PROPOSED CARE HOME DEVELOPMENT - 22/03452/F

OS PARCEL 6920 - EAST OF OXFORD ROAD AND ADJOINING AND SOUTH OF CANAL LANE, BODICOTE.

TECHNICAL NOTE 1 – REPLY TO OXFORDSHIRE COUNTY COUNCIL CONSULTATION RESPONSE DATED 21ST DEC 2022.

11TH JANUARY 2023

Client MERCIAN GROUP			
Project CARE HOME DEVELOPMENT AT LONGFORD PARK ROAD, BODICOTE, OX15 4AD			
Drawing PROPOSED SITE PLAN			
Scale 1:250 @ A1	Date 01.11.2022	Drawn ZK	Checked MP
Job No. 5196	Dwg No. PL02	Revision B	Status PLANNING

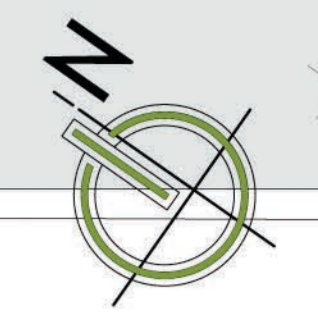
Electric Vehicle Charging Infrastructure is required at a ratio of 25% of all spaces as per policy set out in the adopted Oxfordshire Electric Vehicle Infrastructure Strategy and Oxfordshire County Council's adopted Parking Standards.

A section of footway is required on the southern side of the site access in order to provide refuge for pedestrians leaving the site and heading south, reducing the risk of conflict with vehicles turning into the site.

The proposed provision for cycle parking is significantly below the minimum level set out in the OCC Parking Standards. While some reduction may be acceptable, based on the type of development proposed, the provision for cycle parking needs to be justified, taking account of the site's location and the need to encourage sustainable travel.

From the access junction, along the short access road, there is a footway on the northern side but nothing on the southern side. I consider that a section of footway is also required on the southern side of the access road in order to provide refuge for pedestrians leaving the site and looking to head south, who would otherwise likely be walking in the access road carriageway. This would reduce the potential for conflict between pedestrians leaving the site and vehicles turning in. I consider this particularly important given the increased likelihood of pedestrians using walking aides. **Objection**

The planning documents make no reference to the provision of EV parking infrastructure at the development and it appears from the layout plans that no EV charging spaces are proposed. The adopted Oxfordshire Electric Vehicle Infrastructure Strategy and OCC Parking Standards set out that a provision of 25% of all spaces for new employment developments are required to have EV charging infrastructure.

The application documents set out that a total of 10 covered cycle parking spaces are proposed. This is significantly below the level set out in the OCC Parking Standards for residential care homes, which is at a ratio of 0.5 spaces per bedroom with spaces to be available for residents, visitors and staff.

The cycle parking is currently shown as being located directly adjacent to the bin store. This is not ideal for encouraging cycling, especially during the summer months. I would request therefore that the location of the cycle parking be reconsidered.

- 2.2 The revised site layout plan at **Appendix 2** shows five electric car parking spaces equating to provision at 12.5%. These electric spaces will be active spaces, fully operational from the day of opening. 15 Passive electric space will also be provided.

- 3.2 The proposed site layout plan at **Appendix 2** has been amended and a section of footway on the southern side of the site access, immediately adjacent to Longford Park Road been incorporated into the design.

- 4.2 OCC guidance indicates that 0.5 cycle spaces should be provided per bed. This would equate to 64 cycle spaces accommodated via 32 Sheffield style strands. This is considered to be grossly excessive.

- 4.3 It is noted that residents would not cycle or own a cycle, hence any parking demand that may otherwise occur directly from the 128 residents can be discounted. The residents are too infirm to cycle. Thus, cycle parking demand is attributable to staff and visitors only.

- 4.6 The figure of 64 cycle spaces is clearly grossly excessive relative to the peak staffing level of 40 to 44, maximum.
- 4.7 National Census data can be used to gauge the level of cycle use. This data was presented at Figure 2.6 of the Travel Plan and was given as 2.2%. If this percentage is applied to the 40 staff then this would suggest that around one staff member would cycle.

- 4.8 A total of 10 cycle parking spaces are being provided; this allows for a substantial amount of growth in cycling were it to materialise via the travel plan, or if the occupier has a high level of cycle use outright. Cycle use can also be monitored via the Travel Plan, reported to the local authority as part of monitoring process and the level of cycle parking increased as necessary.
